**PLANNING COMMISSION
STAFF REPORT**

AGENDA ITEM: Planning File No. 297-17-DA: A Development Application review of the proposed Vistas on Granite Street multi-family residential project

LOCATION: 317 Granite Street / Lots 21-24, Block 9, Frisco Townsite

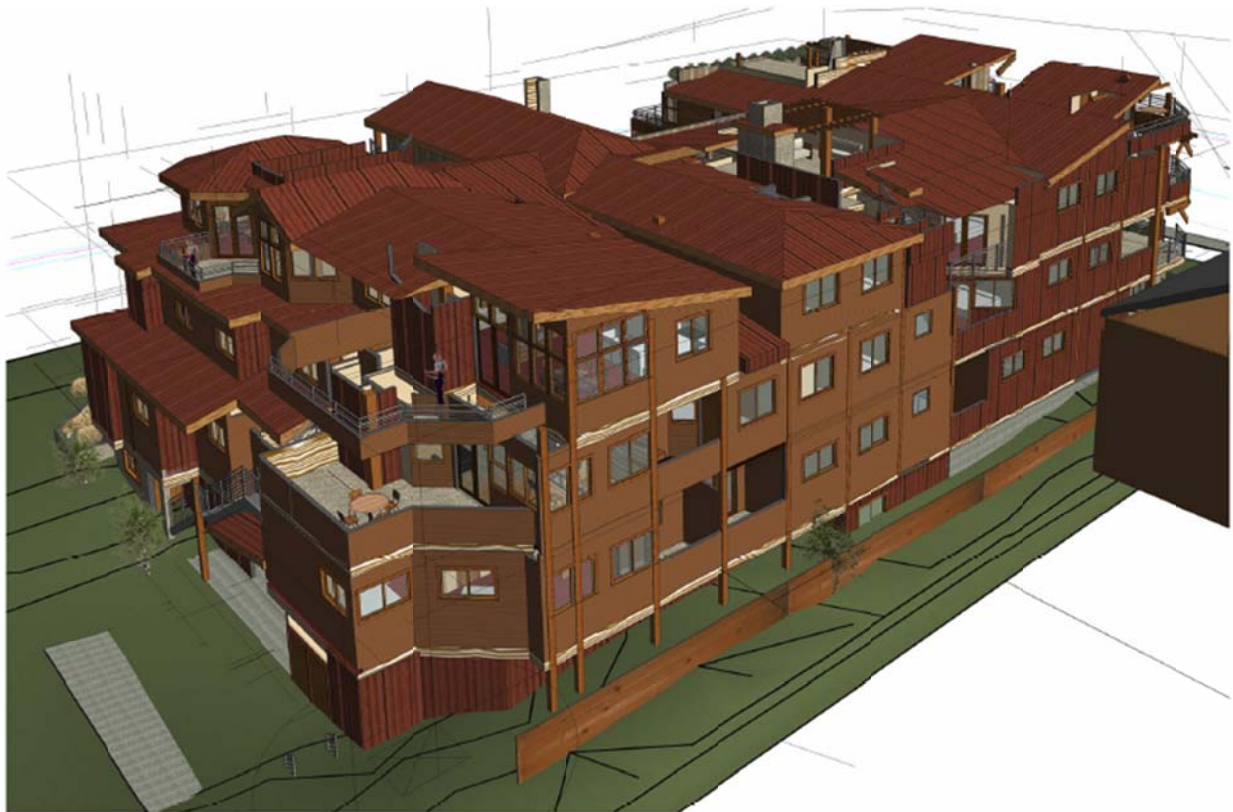
Standard #1.2: *Buildings shall be designed to provide deep (at least 24 inches) eaves and overhangs, and other building elements that provide shelter from natural elements and provide visual relief, including the use of porches and patios to add interest along street yards. When a substantial number and variety of building elements are utilized the eaves may be less than 24 inches deep in some locations.*

The proposed building has a variety of pitched roof forms and elements with roof eave depths between (1) and two (2) feet. The roof forms with eaves of less than 24 inches in depth are allowed since the proposed structure includes a substantial number and variety of building elements. The application meets this standard.

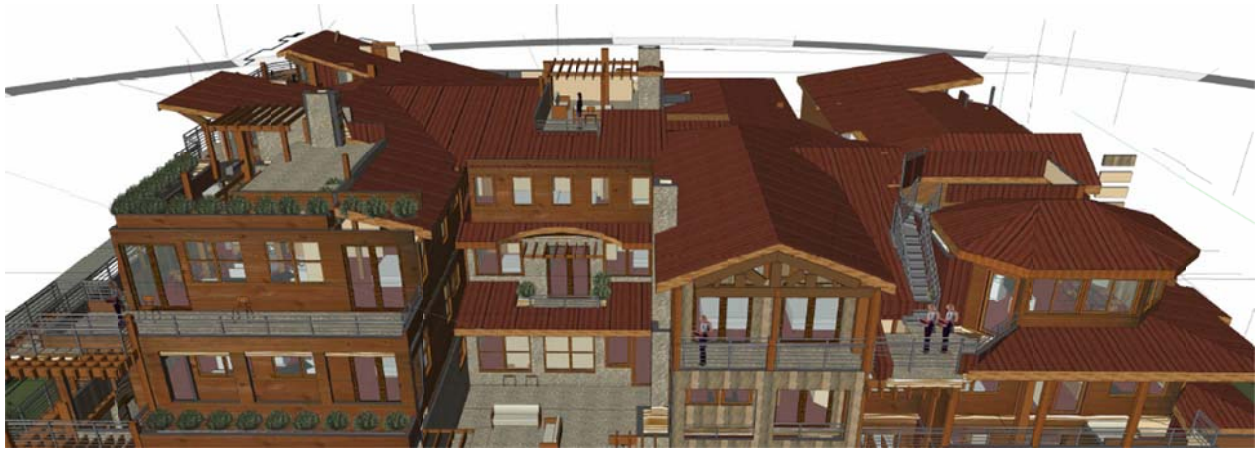
The roof elements are of an architectural design which complement historic roofs in the area and the neighborhood. Shed roof elements are provided and can be seen from the public rights of ways. The application is consistent with this goal.

The roofs on the proposed building have a variety of pitches including 2:12, 2.25:12, 2.75:12, 3:12, 3.75:12, 4:12 and 4.25:12 roof elements. At the sketch plan review, concerns were raised regarding long roof ridge lines running east-west. The applicant has further broken up the roof lines since the sketch plan application to come into compliance with Standard #4.2. The application meets this standard.
